SUBJECT: Addendum No. 4

RE: Invitation to Bid (ITB) Solicitation No. H93-IAHDRR-2024-026, IAH Terminal D Restroom Renovation at Multiple Gates at George Bush Intercontinental Airport (IAH); Project No. 971

IAH Terminal D Restroom Renovation at Multiple Gates at George Bush Intercontinental Airport (IAH)

This revision is a clarification of fixtures, finishes and MEP changes. All sheets now show the TIP/BSG numbers on the TTB. This clarification involves the following documents:

SHEET NAME: SECTION DETAILS
SHEET No. A-511 SCALE: 1 1/2" = 1'-0"
SHEET SIZE: 30"x42" ARCH E1

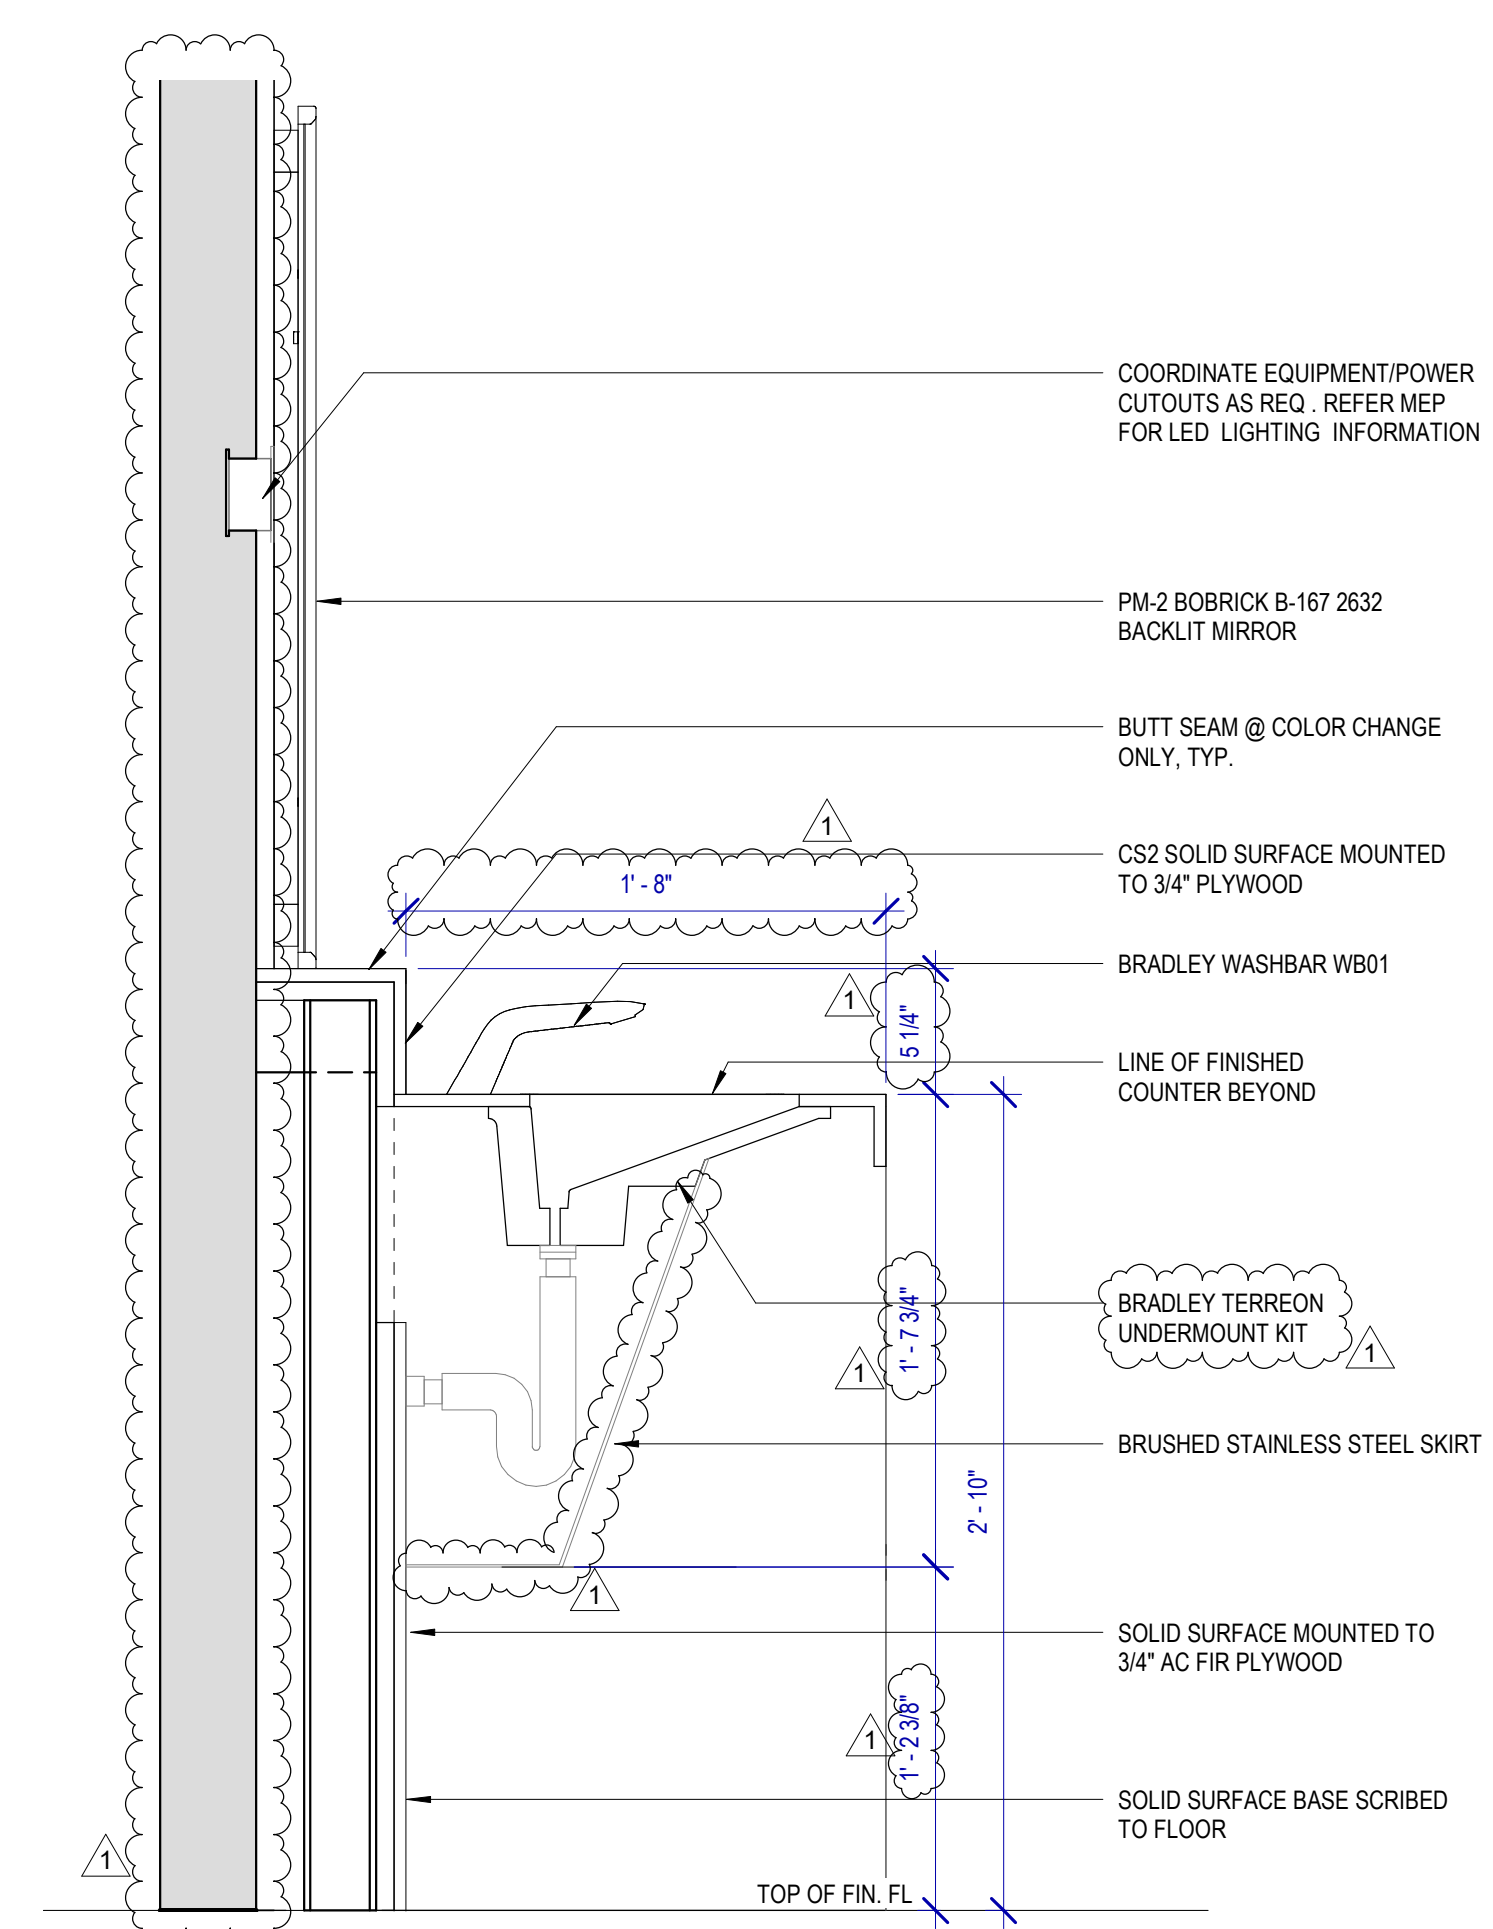
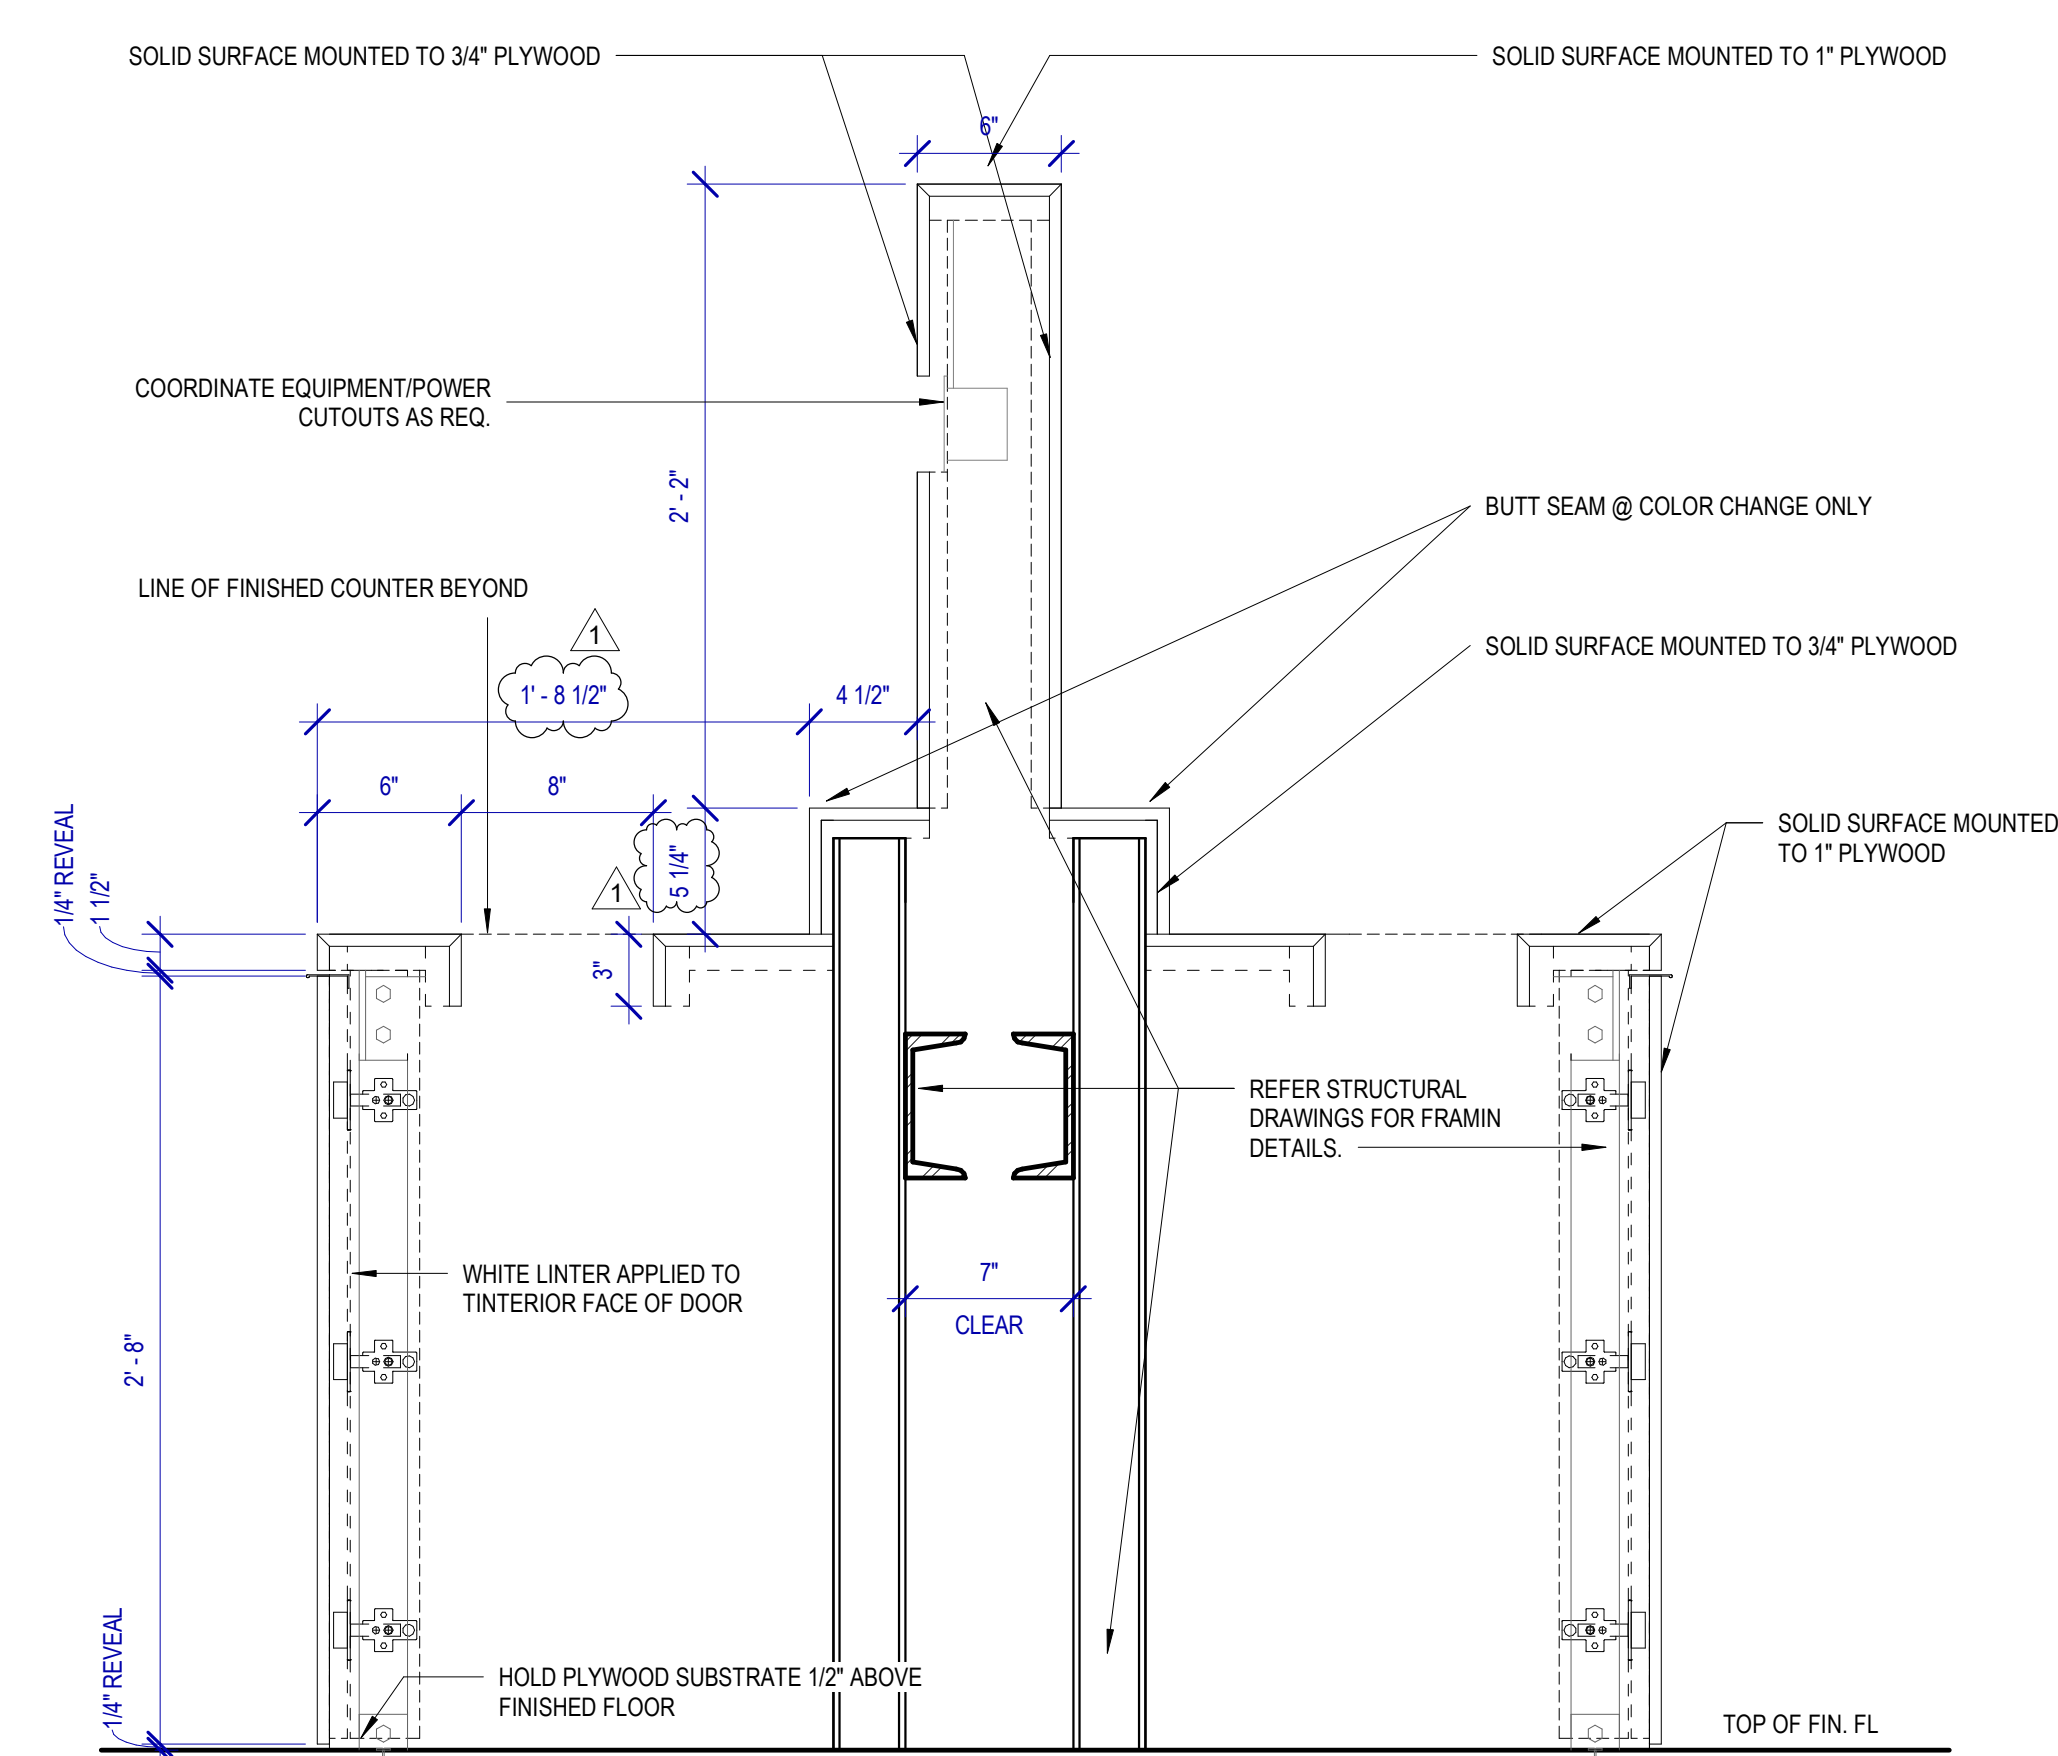
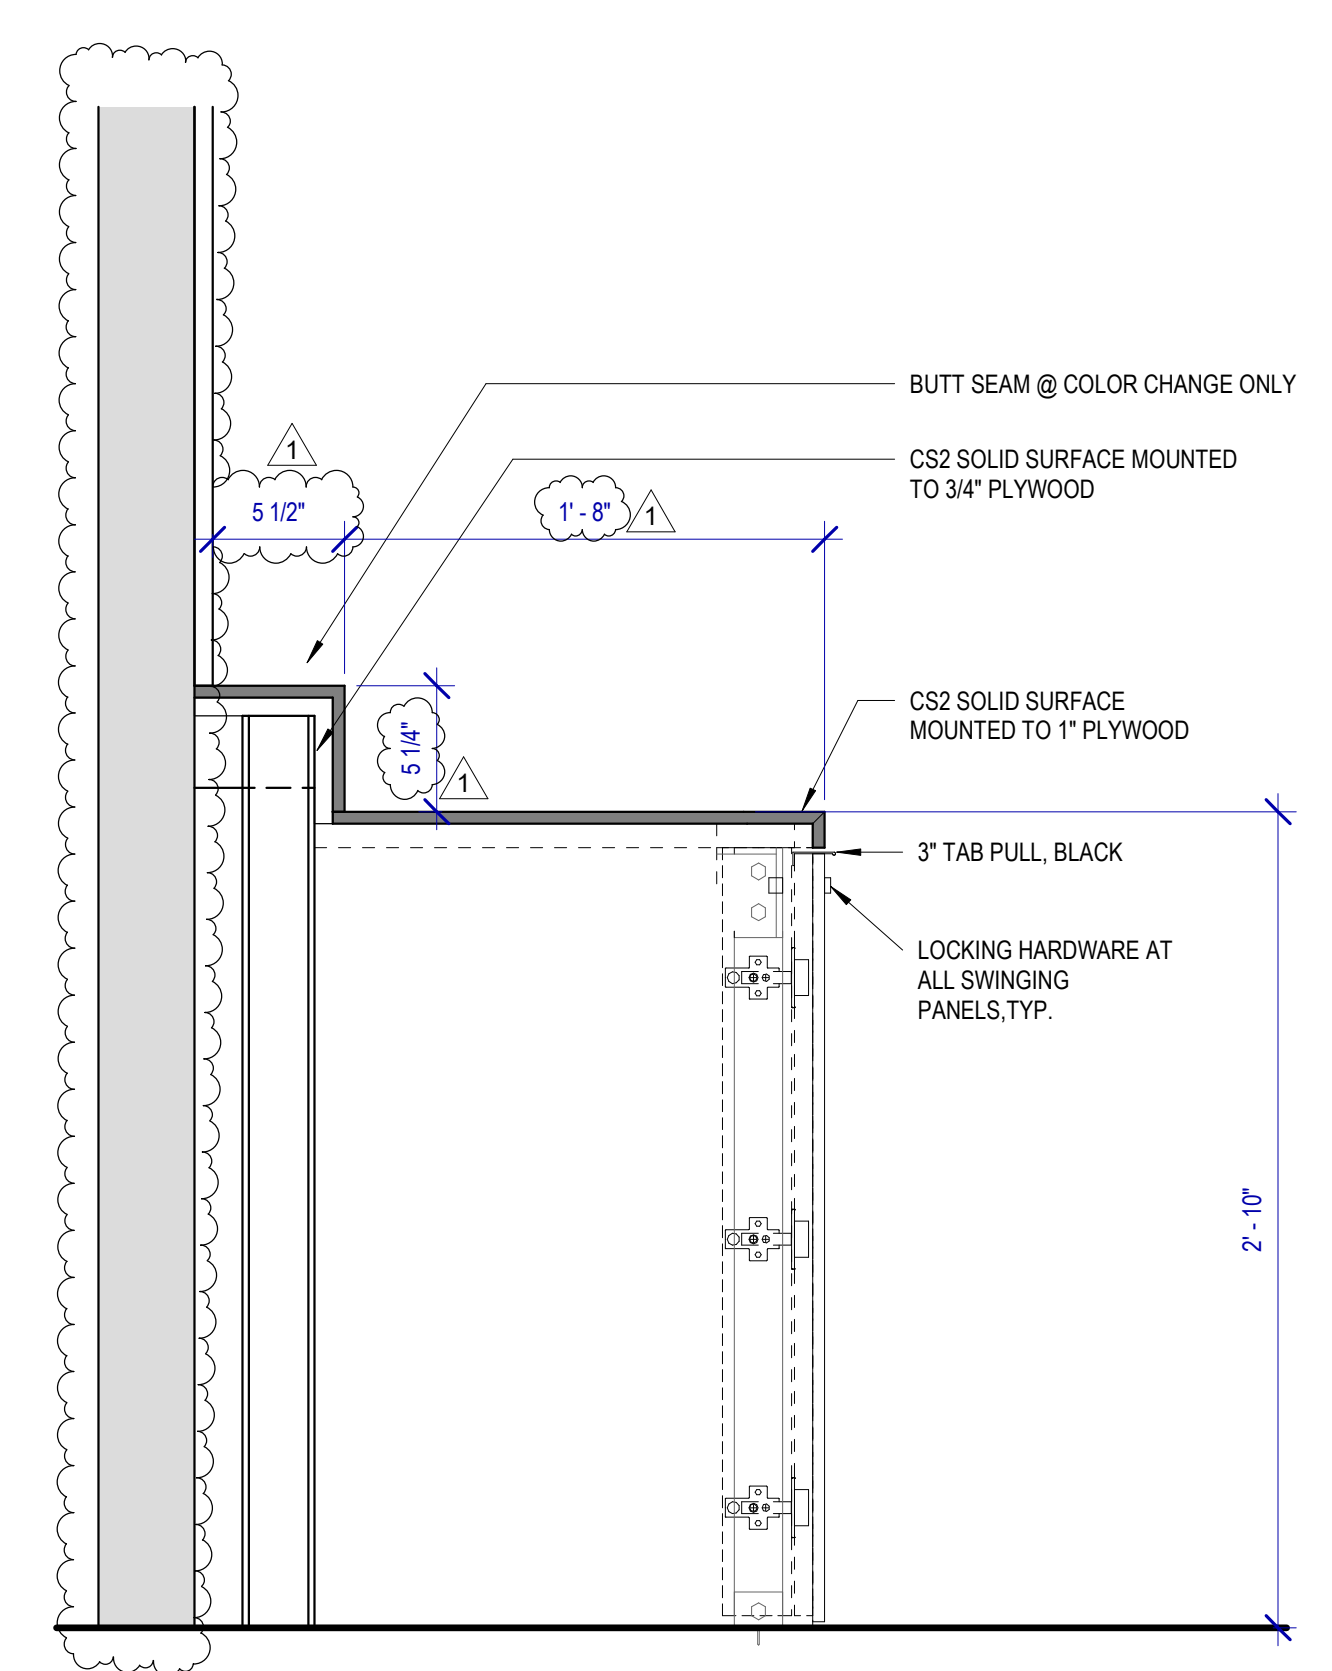
A-511: revised details dimensions and fixtures.
